NOTICE OF DECISION

HISTORIC DESIGN REVIEW CASE NO.: HIS19-10

SUMMARY: A proposal to repair the brick wall and replace the windows on the rear façade of the South Eldridge Block (1889).

**HISTORIC DESIGN REVIEW CASE NO. HIS19-10
DECISION**

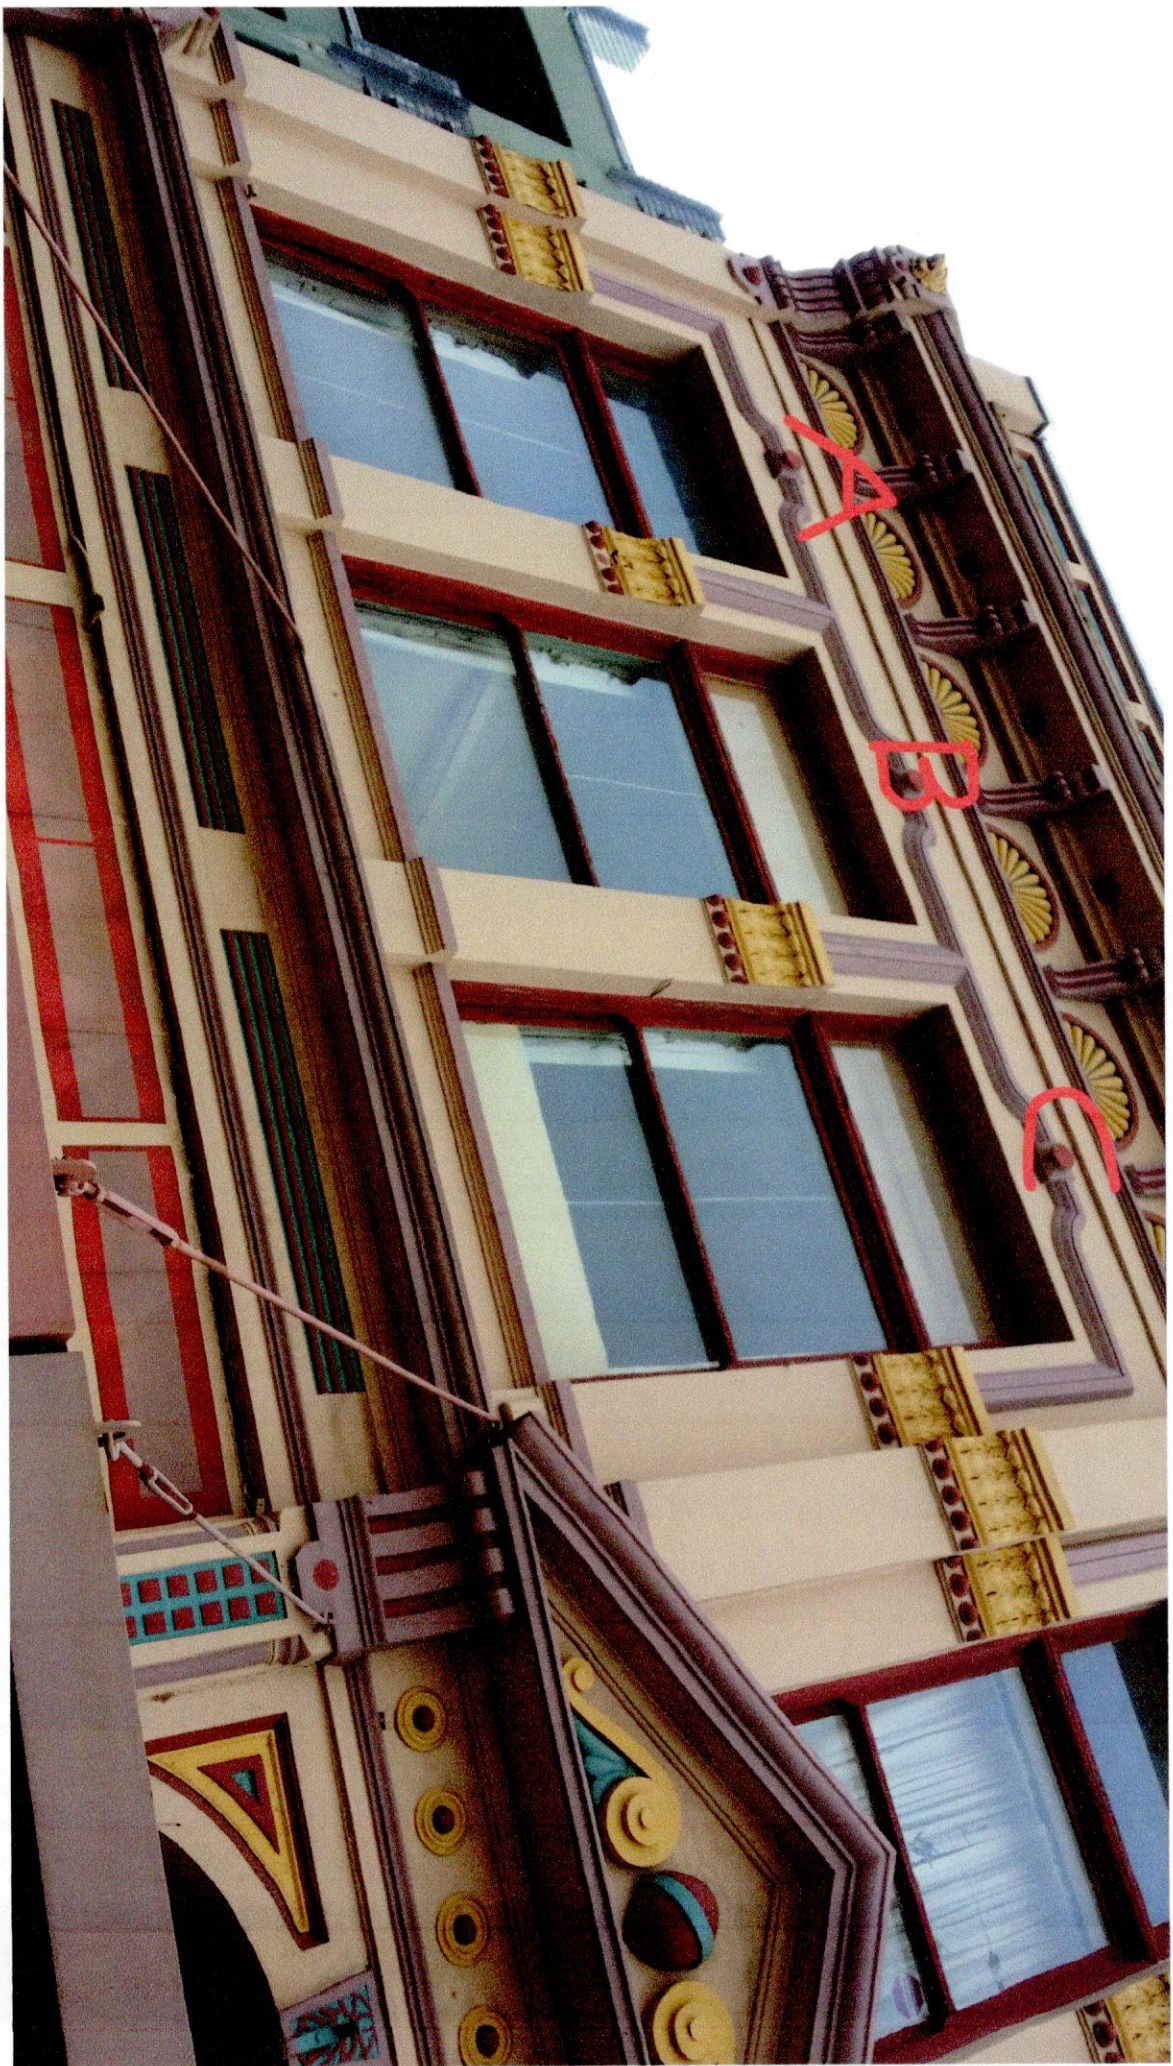
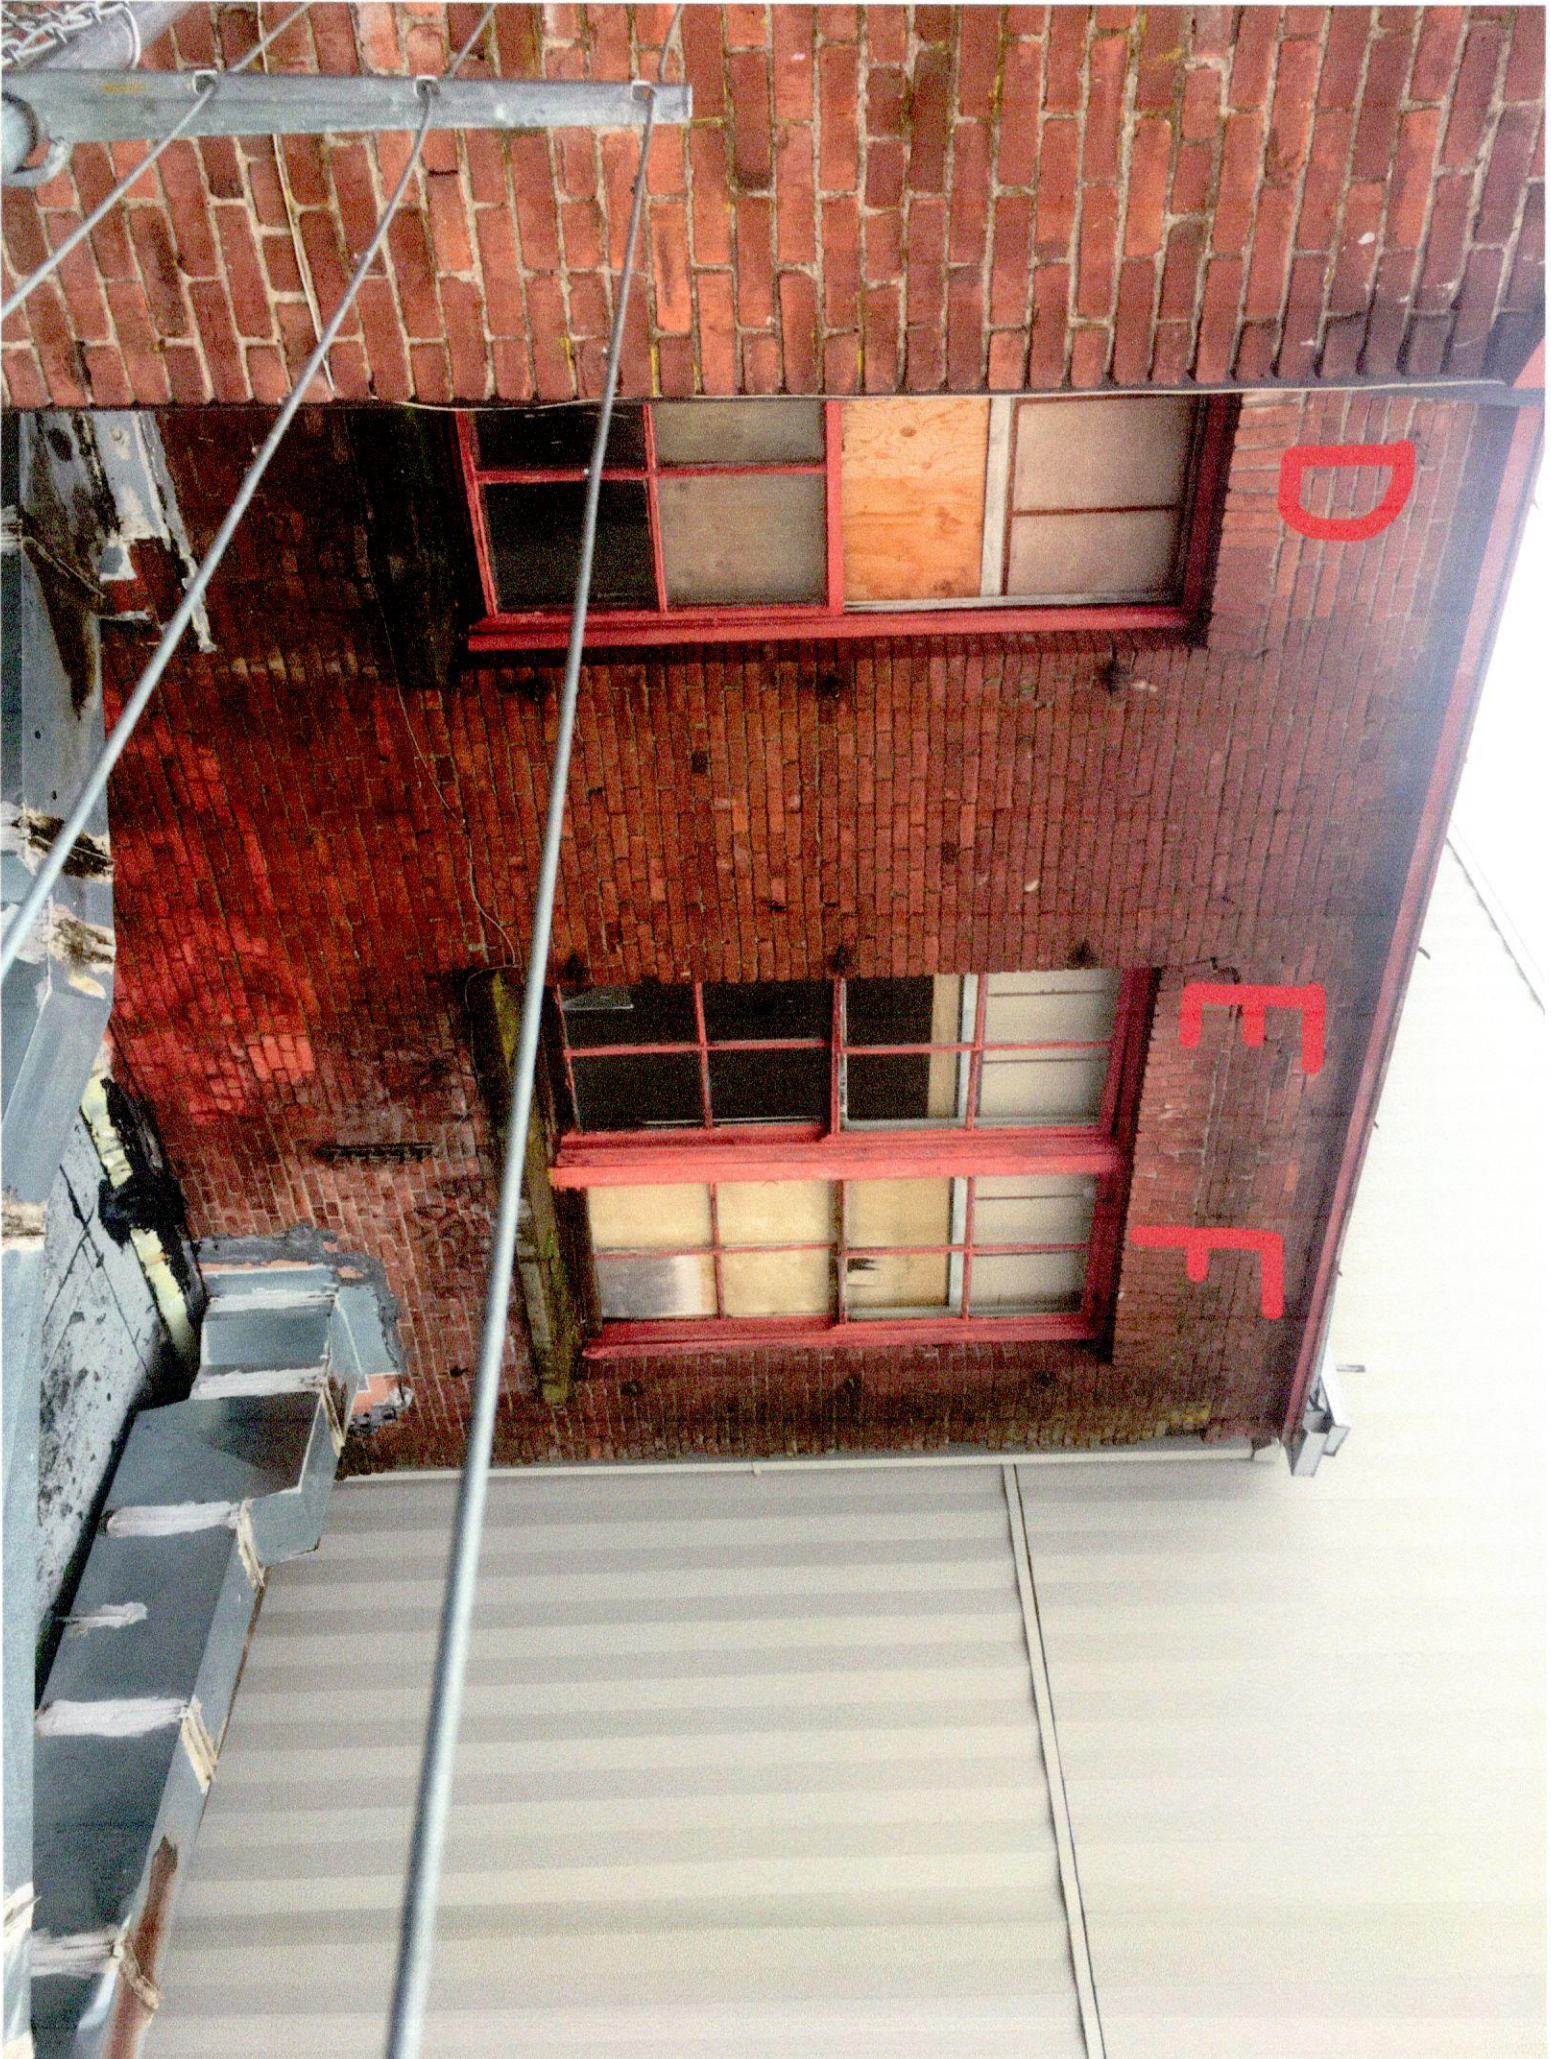
Upon closer examination of the wall mentioned above, we found severe cracking of the mortar joints and missing brick at the NE corner of the second story. Even more so, the “Flat – Bounded Arch” of the most Northern Window on the East Elevation, we found that the brick on the window crossover has dropped 2” inches and has rolled out proud of the building almost 2” inches as well.

We took immediate action in shoring the Existing brick to avoid collapse.

The brick needs to be dismantled from the top of the wall, down to the bottom of the arch and then reconstructed in its original fashion.

After removal, I would suggest a Steel Lintel being place at the crossover for strength and longevity as the “Flat Arch” is the weakest arch constructed but it would still keep its historic integrity

Both windows on the second story east elevation are have severe dry rot and need to be replace.

The northern window will need to be removed to rebuild the Flat Arch correctly and I have little confidence it can be salvaged.

ELEVATION (EAST) of 254 COMMERCIAL STREET N.E.

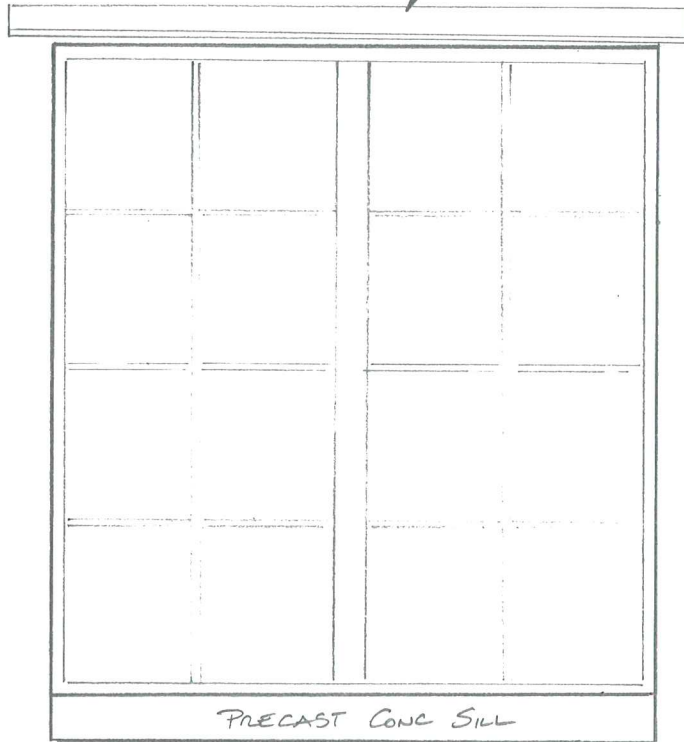
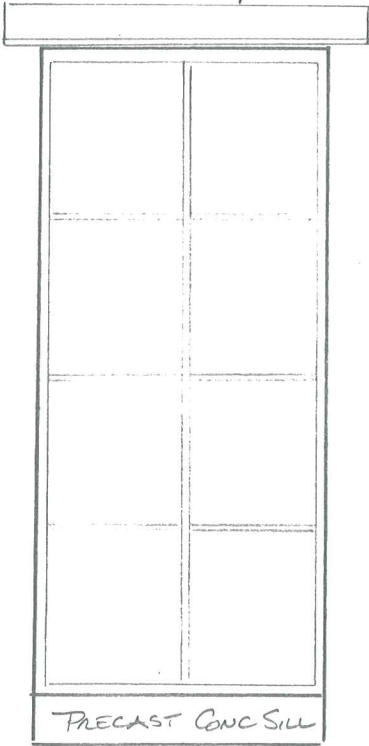
Scope: Existing turn-of-the century unreinforced brick masonry lintel facing east above windows is failing. We have been asked to size a steel lintel to add reinforcing underneath this masonry lintel to provide long term support.

(N) L6x4x5/16
LINTEL ↘

(N) L8x4x1/2
LINTEL ↘

Finding: The applicant is not proposing to substantially alter the exterior appearance of the brick wall at the rear of the structure. The addition of the steel lintel is necessary to reinforce the wall, and will not substantially alter the exterior. Staff finds that this standard has been met.

FILE NO. 190241 SHEET NO. SK2
 MADE BY DSM DATE FEB 2019
 CLIENT Pacific, LLC
 PROJECT 254 COMMERCIAL STR NE LINTEL

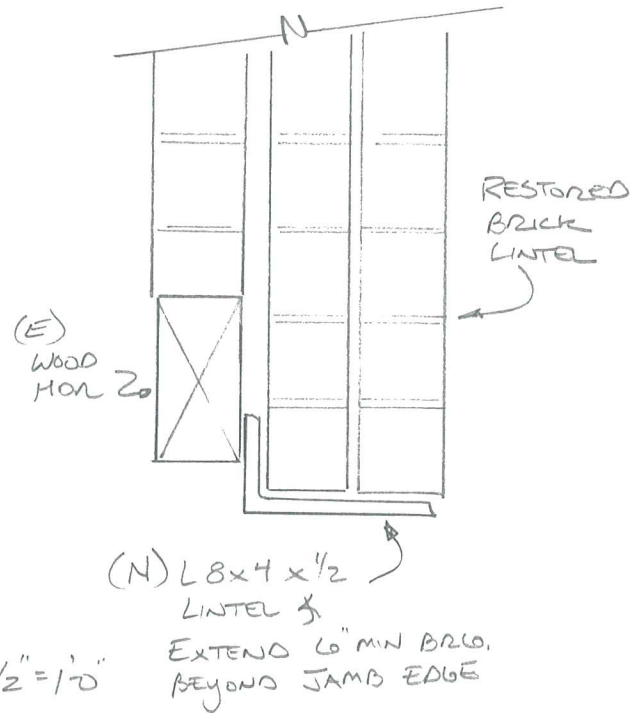
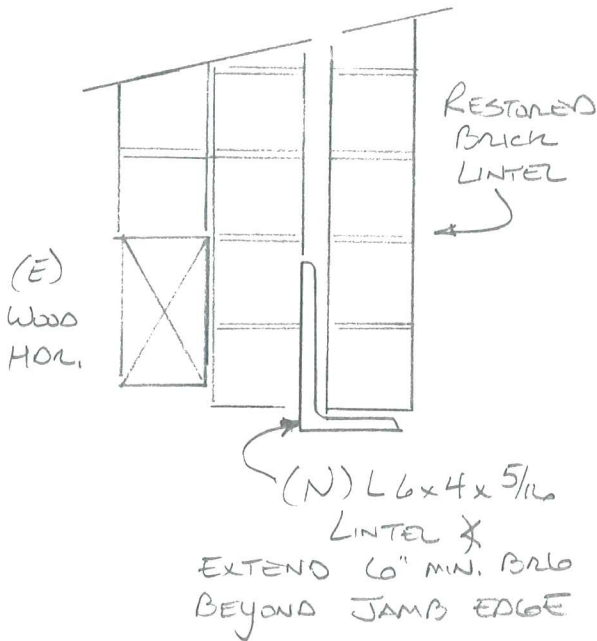
SPAN = 8'-6"

$w_{OL} = 86 \text{ psf} \times 2'-9" = 236.5 \text{ plf}$

$M = 236.5 \times 8.5^2 \times 12/8 = 25,630$

$S_{REQ'D} = 25630 / 20,000 = 1.28$

L8x4x1/2 S = 2.15 ✓

$\Delta = 0.1421" \Rightarrow 7/717.7 \checkmark$

SPAN = 4'-4"

$w_{OL} = 236.5 \text{ plf}$

$M = 236.5 \times 4.33^2 \times 12/8 = 6651$

$S_{REQ'D} = 6651 / 20,000 = 0.333$

L6x4x5/16 S = 2.79 ✓

$\Delta = 0.0057" \Rightarrow 4/9133 \checkmark$
